Re: REPLAT OF LOT 168, BLOCK 1 LAKELAND RANCH SECTION FOUR Subdivision Plat Engineer's Recommendation

Acting in the capacity of the Tyler County Engineer, Goodwin-Lasiter-Strong has reviewed the Application for REPLAT OF LOT 168, BLOCK 1 LAKELAND RANCH SECTION FOUR for compliance with the Tyler County Subdivision Regulations.

REPLAT OF LOT 168, BLOCK 1, LAKELAND RANCH **SECTION FOUR**

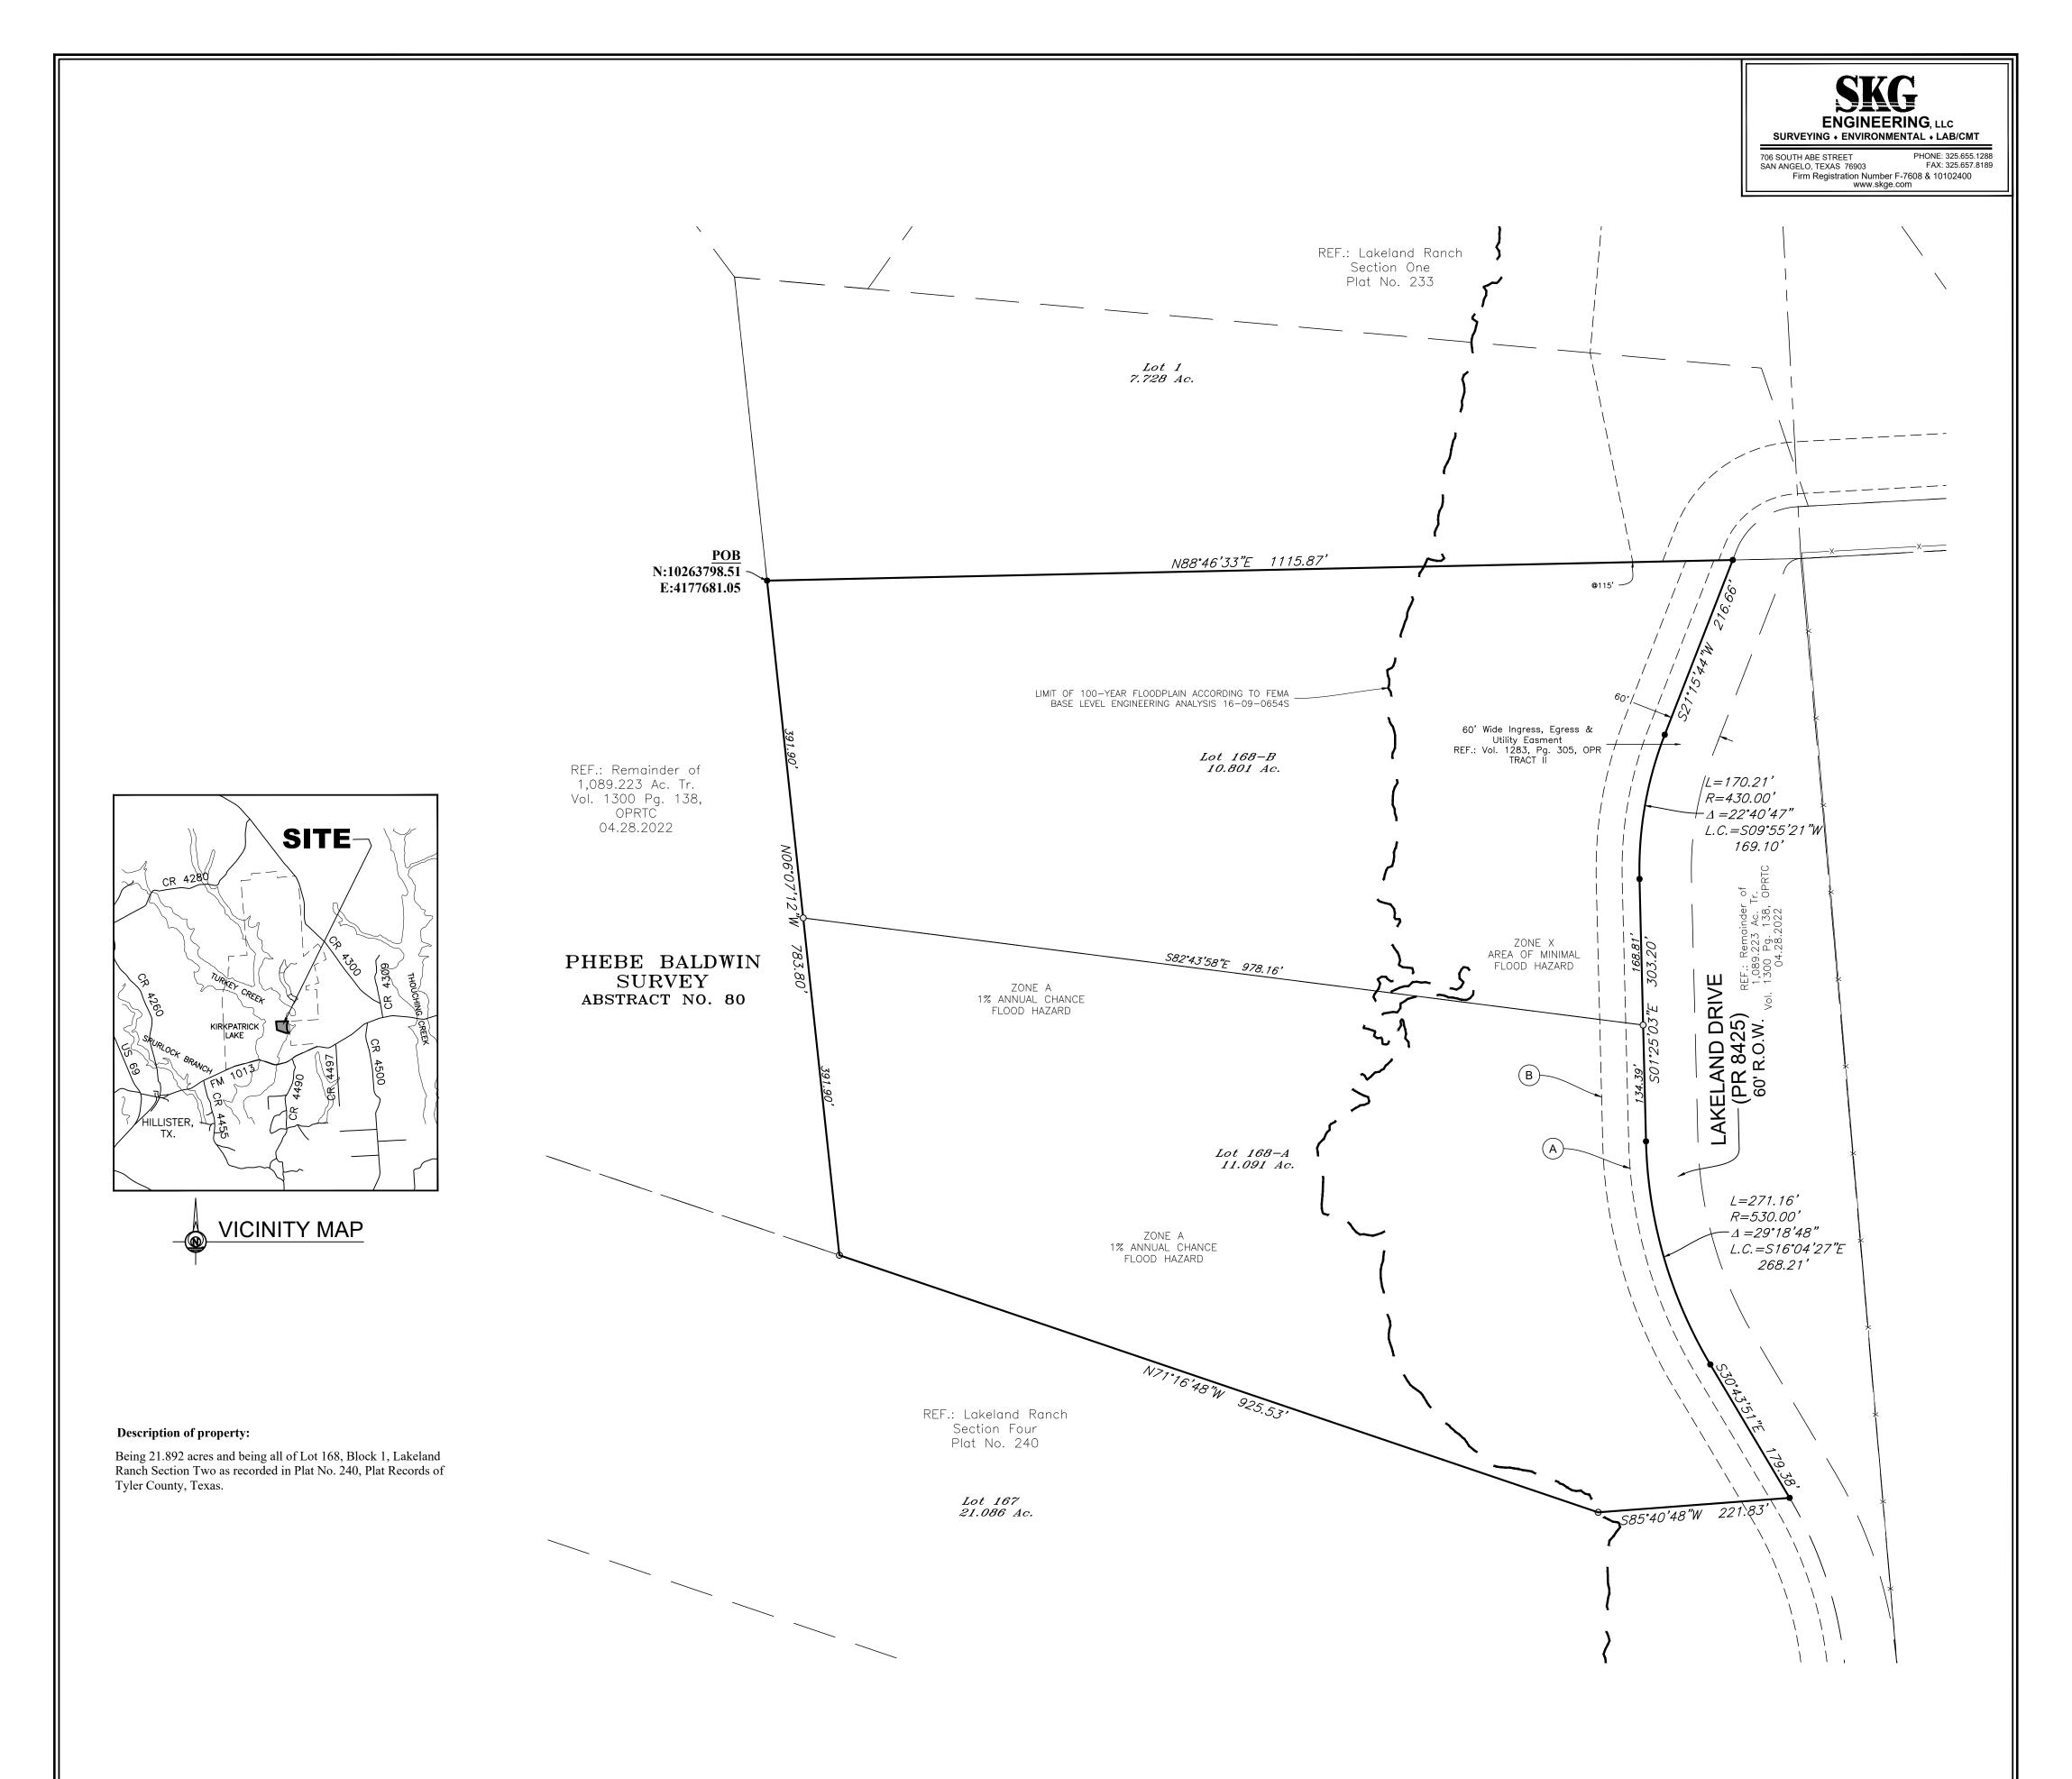
The proposed replat conforms in all respects to the requirements of the Tyler County Subdivision Regulations.

Section 10.1 of the Regulations contain notice requirement for the replat. Section 10.1.i. of the Regulations states: "If a petitioner obtains unanimous written consent from all owners of the property within a subdivision agreeing to the proposed amendment, the necessity for notice under this subchapter are waived." Lakeland Ranch LLC has provided written consent to the replat from the owner of Lot 161. Lakeland Ranch states that they own all of the other lots of SECTION FOUR. Therefore, I recommend that the notice requirements of the Regulations be waived in accordance with Section 10.1.i.

We recommend **approval** of the application.
